Project Name:	Hiflex House, Salisbury
Document Reference:	020.0817/HRN/2
Document Name:	Highway Response Note
Prepared By:	Caitlin Turley (November 2023)
Checked By:	Jessica Miller (November 2023)
Approved By:	Shaan Novitzki (November 2023)

1. INTRODUCTION

1.1 This Highways Response Note has been prepared on behalf of Store Property Investment Ltd in response to highways comments raised in relation to the planning application for the *"Demolition of existing office building and development of a new building to provide 2no Use Class E(g) / B2 industrial and B8 Storage / Distribution units, including associated infrastructure, access, and parking"* (ref: PL/2023/07414) which was validated in September 2023. The planning application was supported by a tracking diagram illustrating a 16.5t articulated vehicle entering and exiting the site, along with turning around on site. The site layout is shown in **Figure 1**.

Figure 2: Existing and Proposed Parking

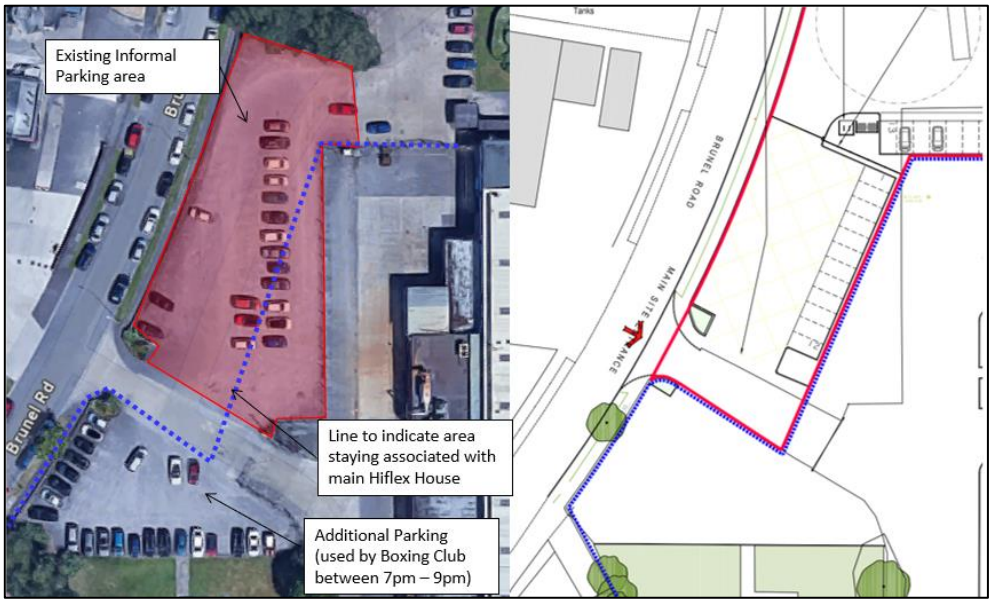
2.3 The planning and highways officer asked for clarity regarding the loss of the informal parking area located directly to the north of the site access road (as shown in red in **Figure 2** below). The existing and proposed parking is demonstrated in **Figure 2**.

2.4 The existing office space, which is to be demolished measures approximately 1,753m^2 and the proposals are for 1,962m^2 of B2 General Industrial. The existing site currently features 33 car parking spaces, which are formalised, with an additional area directly to the north of the main access road which provides informal car parking. Whilst there are no delineated bays, it is estimated that this area could accommodate up to 40 vehicles. However, not all this parking is utilised and operates informally.

2.5 The development proposals will provide a total of 38 delineated bays. 26 of these will be located next to the entrances to the new buildings. 12 spaces will be located directly to the north of the access road where the existing hardstanding is. The existing hardstanding will be split into two sections, with the western section designated to the new proposals where the 12 bays are situated. There is also space for over-flow within this area if required.

2.6 The eastern side will be designated for use by the retained Hiflex House operations (occupied by Argus Fluidhandling). Currently the area is shared between all uses on site, therefore a direct comparison is not available. This area will be formalised as part of the proposed application to accommodate circa 6 – 7 vehicles however there will remain ample space for parking for the existing use across the site.

2.7 Overall, the parking provision equates to 38 spaces for the two new units and 6 – 7 for the existing Hiflex House. There is also an area of hardstanding to the south of the main Hiflex House building where vehicles can park, therefore, any overspill can be accommodated within the site.

Title
16.5M ARTICULATED VEHICLE SWEPT PATH ANALYSIS

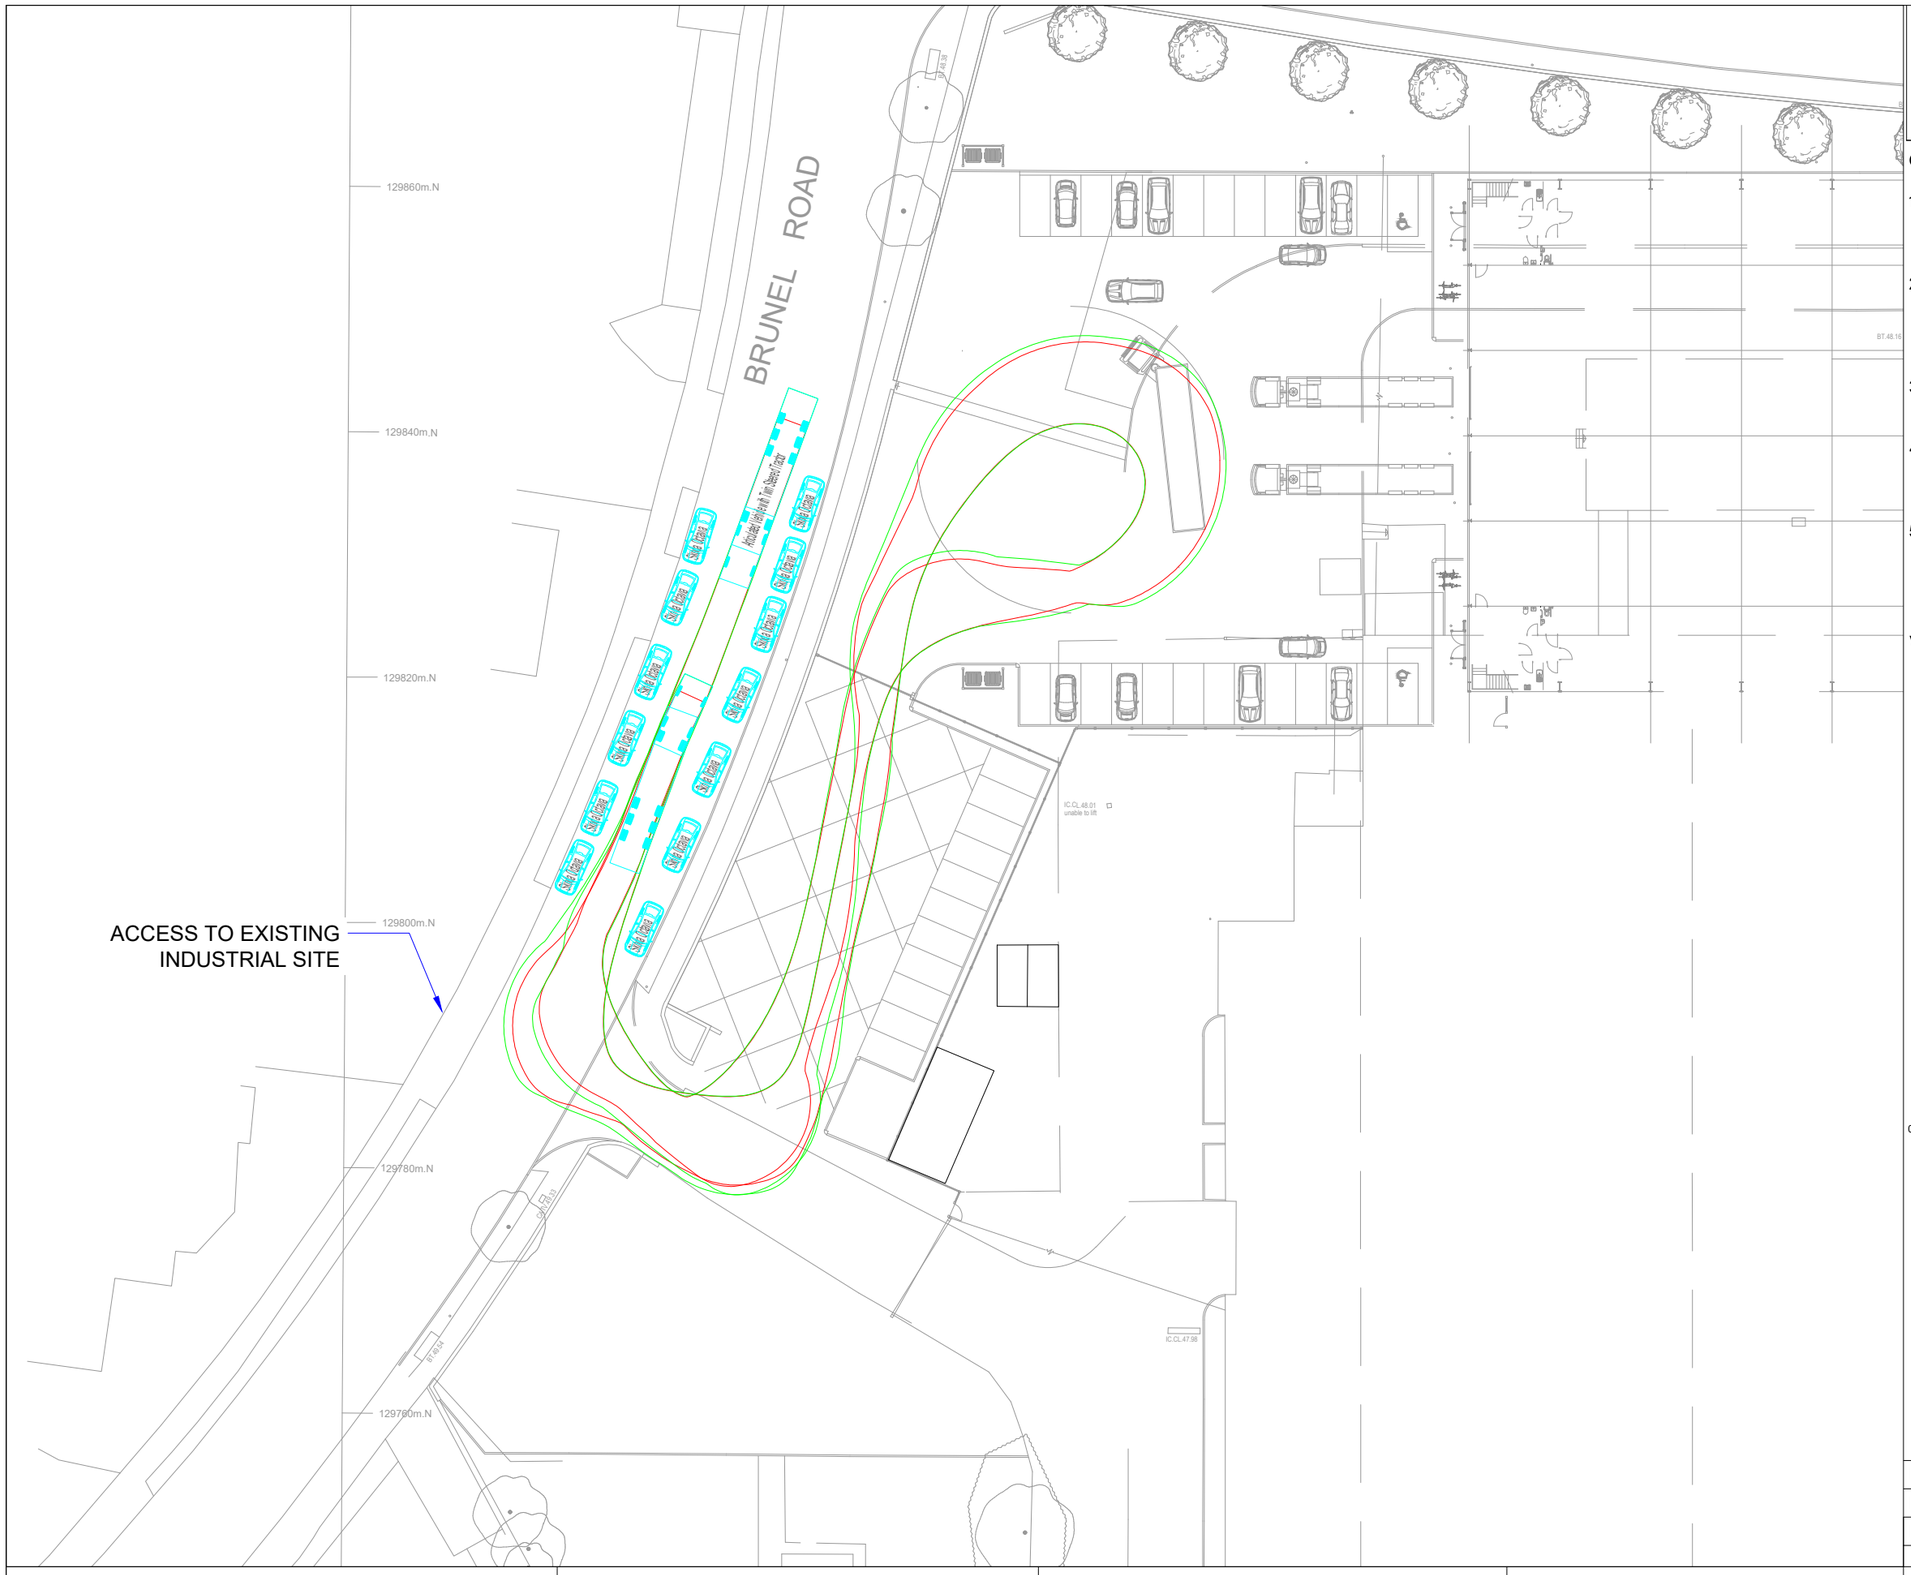
"The carriageway is not drawn and there is 3 lines of traffic, so I can't see that the tracking is within the carriageway. From measuring on screen from both our mapping system and the location plan, the carriage measures between 8.5 and 9m in width, the swept path drawing including all the tracking measures nearly 12m, if this is what is shown, it clearly will not work. Please can this be confirmed, and the tracking be re-drawn showing the extent of the highway/carriageway/footways."

2.2 In response to this comment, the tracking has been updated to show the opposite side of the road along with the existing parking which occurs on the road. This is included in Appendix A and confirms that an articulated vehcile can enter and exit the site. It should be noted that the same arrangements for articulated access occurred as part of the previously approved application (ref: PL/2021/08333). In addition, the access currently facilitates articulated vehicle access, and this does not cause any issues. Therefore, this application is not expected to result in any impact on the operation of this access or the parking on street given its existing and current use with articulated vehicles, as referenced in paragraph 1.2.

3.3 To address these points, the tracking has been updated using OS mapping which demonstrates that a 16.5t articulated vehicle can manoeuvre into and out of the site. In addition, the proposed uses are expected to generate the same vehicle type as the current occupants of Hiflex House which are sufficiently able to enter and exit the site.
